Subject: Starwood Power-Midway, LLC Peaking Project Amendment (06-AFC-10),
Amendment No. 1
URS Project No. 27656131

**STARWOOD POWER-MIDWAY, LLC PEAKING PROJECT
(06-AFC-10)
AMENDMENT No. 1**

**SUBMITTED TO THE
CALIFORNIA ENERGY COMMISSION
APRIL 2008**

Figure 1-1	Revised Plot Plan
Figure 1-2	Architectural Rendering of the Project Site After Construction

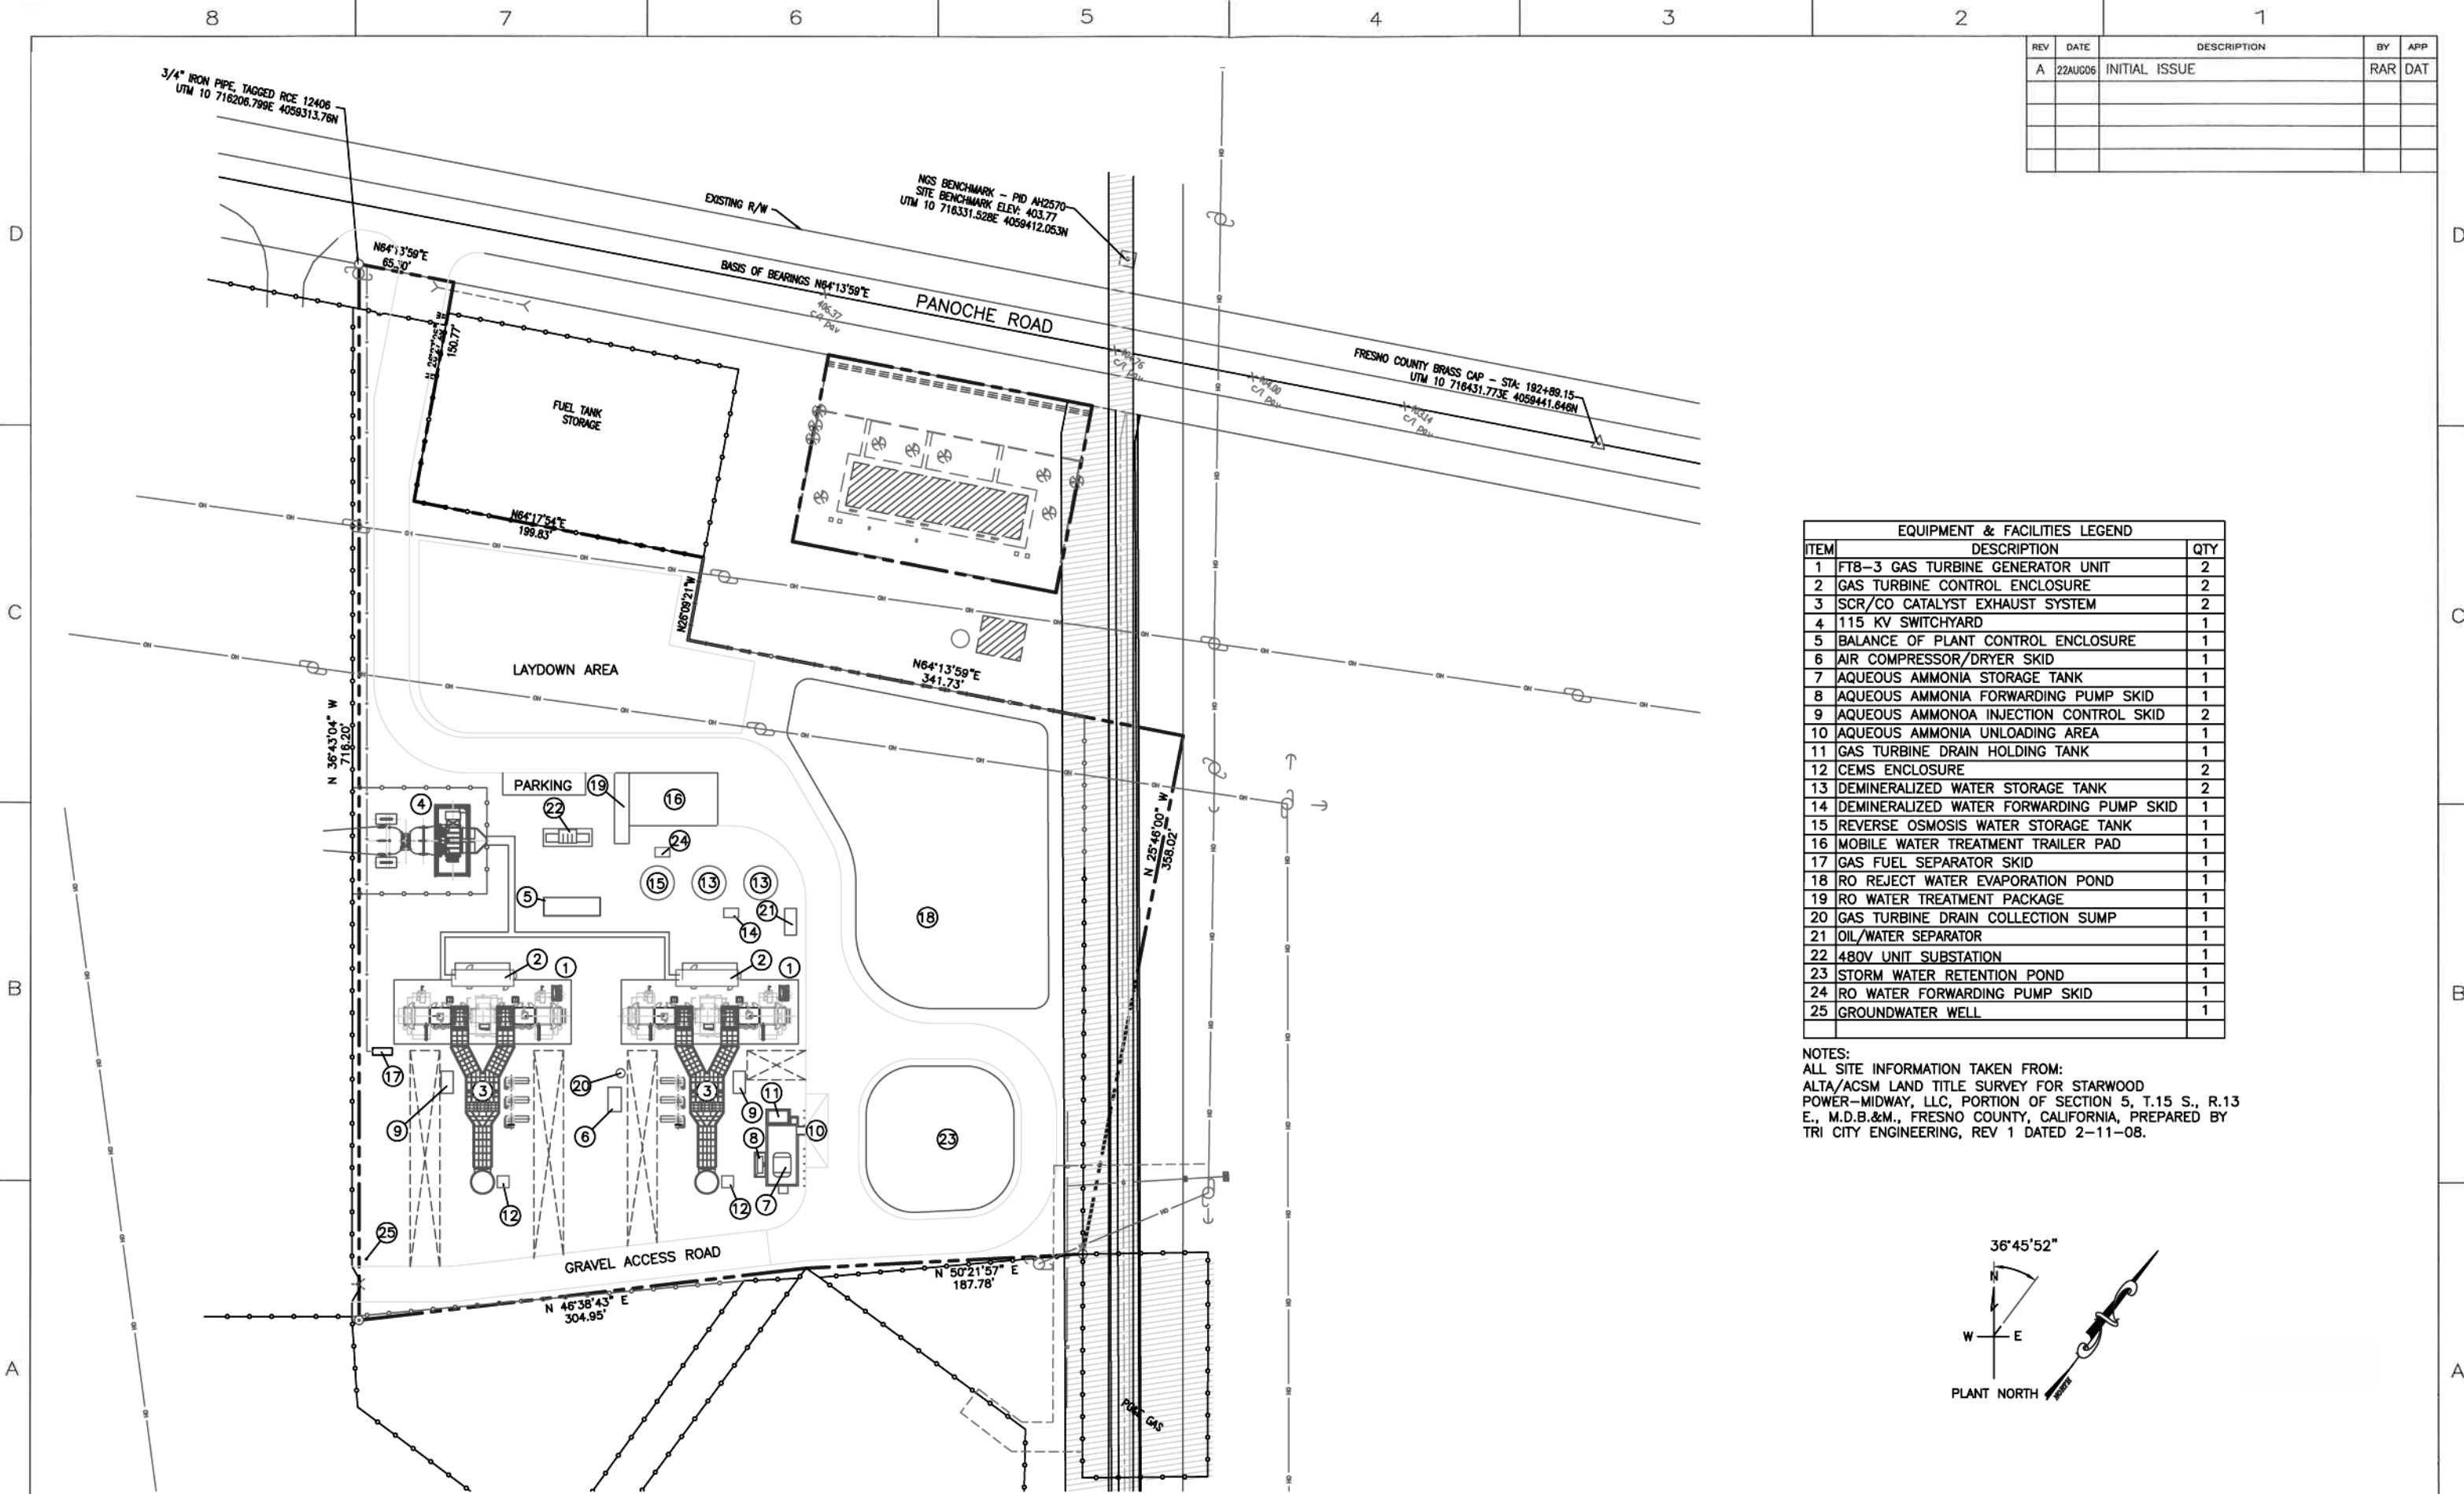
- 1) The stormwater retention pond (Item #23) and RO pond (Item #18) configuration was modified to avoid PG&E gas line easements located on the east side of the Project site. The ponds were resized due to the expected quality of the RO reject water.

- a. The revised stormwater pond depth is 6ft, total volume is 37,000 cubic feet, the bottom surface area is 3,540 sq. ft. and top surface area is 8,860 sq. ft.

- b. The revised RO pond depth is 6ft, total volume is 133,000 cubic feet, the bottom surface area is 14,500 sq. ft. and top surface area is 29,600 sq. ft.

- 2) The gravel or paved access road was modified to account for the reconfiguration of the ponds and to avoid high voltage (HV) transmission pole located in the middle of the site as indicated by the latest Tri-City survey. A gravel road was added to the south side of the units for a secondary path of egress from the site to address permit requirements.

- 3) The construction lay down area has been increased from 11,050 sq. ft. to 20,000 sq. ft within the revised site plan.
- 4) The parking area length has been reduced to 70 ft. from 110ft. The location of the parking area has also been repositioned. It is now located south of the construction lay down area and north of the 480v Unit Substation on the revised site plan.

- 1) Combustion Turbine Generator (CTG) Packages (Item #1 on revised site plan): Unit 1 has been shifted west approximately 19 ft. Both Units has been shifted 5 ft. south. This will increase the space between the CTG units for long-term maintenance of the equipment and allow the installation of underground electrical duct banks.

- 2) SCR/RP catalyst exhaust system (Item #3): Due to the decision to procure the latest design of catalyst systems, the ducting flow path for the revised site plan is wider by about 4 ft. and is shorter by about 6 ft. The revised design will be optimized for the FT8-3 engines exhaust flow (Item #1).

- b. The CTG exhaust stack height of each unit has been changed to meet the 40 CRF Part 60 requirements for EPA test port locations. The stack height was increased from 50 ft. to 68 ft. This revised ductwork design will help avoid pockets where natural gas could accumulate, ensuring purging in accordance with the latest NFPA 85 Code (2007 Edition).

- 4) BOP control enclosure (Item #5) has been shifted north approximately 17 ft. This modification was based on detailed design to avoid a 15kV trench and increase space for underground duct banks.

- 5) The air compressor skid (Item# 6) has been rotated 90 degrees. Modification is based on the detailed design for improved routing of piping to interfaces on skid and to avoid interference with underground duct banks.

- 8) The Gas Turbine (GT) Holding Tank (Item #11) has been shifted 34 ft. to provide maintenance access to GT #2A. GT #2A is a designated area on the east side of the CTG unit. This area is located between the CTG Unit (Item #1 on site plan) and the GT Drain Holding Tanks (Item #11). This will allow adequate space for a crane to be located next to the GT enclosure for engine removal.

- 11) The Mobile Water Treatment Trailer Pad (Item #16, but referred to as DI trailer pad on old site plan) has been reduced in size and will be shifted west approximately 50 ft. Based on the detailed design; the pad is sized to handle two trailers at once. The pad being shifted west was due to rerouting of the access road and pond reconfigurations.

- 16) The 480v Unit Substation (Item #22, but referred to as Auxiliary Transformer on old site plan) has been reconfigured to include the auxiliary transformers as well as switchgears for the 480v power distribution and was shifted north. However, this will not be finalized until equipment is procured and vendor drawings received.
